# **New Albany Planning Commission**

February 3, 2025 Meeting Minutes - Approved

## GANTON PARKWAY WEST PHASE 4 FINAL PLAT

APPLICATION: FPL-01-2025

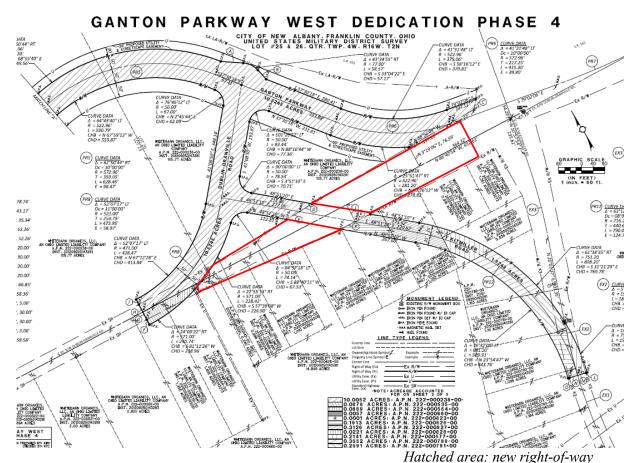
Chair Kirby asked about the alignment and the goals with this alignment.

Commissioner Wallace clarified that the idea here is a portion of Dublin Granville Road would go away in service of the realignment.

Commissioner Wallace traced the route of Dublin Granville Road and the intersections. He further remarked that he did not understand the road transitions, they looked confusing and wayfinding would be difficult.

Commissioner Wallace asked whether there were plans for a roundabout, and what the signal at the intersection would be.

Chair Kirby noted that Kitzmiller Road will be interrupted and will resume, similar to Harlem Road. He asked whether it will alleviate unwanted traffic between Smith's Mill and Central College.

Engineering Manager Denny explained that this was arrived upon with the land donation and the traffic study guided the alignment. One objective was to direct traffic away from the village center.

Deputy Director of Public Safety Mayer added that another goal was to prevent the creation of another five point intersection. Staff found this was a good solution and it provides room for a future roundabout. There will actually be one intersection when it was complete. This would avoid confusion with addressing. He further noted there was a huge grade change

Director Chrysler explained the propsed road transitions. The city released an RFP for the design of the road and the traffic study. The city had been studying it for over a year. She acknowledged that it appeared unusual but this was the solution that made the most sense. She elaborated on the priorities of the analysis, those being the constraints of the wetlands, the Nationwide Childrens' site, the eventual ball field, the location of the historic building, the existing and proposed roundabout. Following analysis, staff concluded that priority number one was to create Ganton similar to Fodor Road

Director Chrysler replied that there were plans for a roundabout. She explained that there will be a stop sign and a second roundabout will be installed. The commission will review a plat for the proposed roundabout and she expected that it would be presented by July 1. She explained that the work on the road will occur in three phases that will be bid out sequentially but in very close temporal proximity.

Director Chrysler replied that Harlem Road is a great example. It has a lower, middle, and upper portion. Kitzmiller Road looked somewhat confusing on the rendering but this solution has been a feat of engineering.
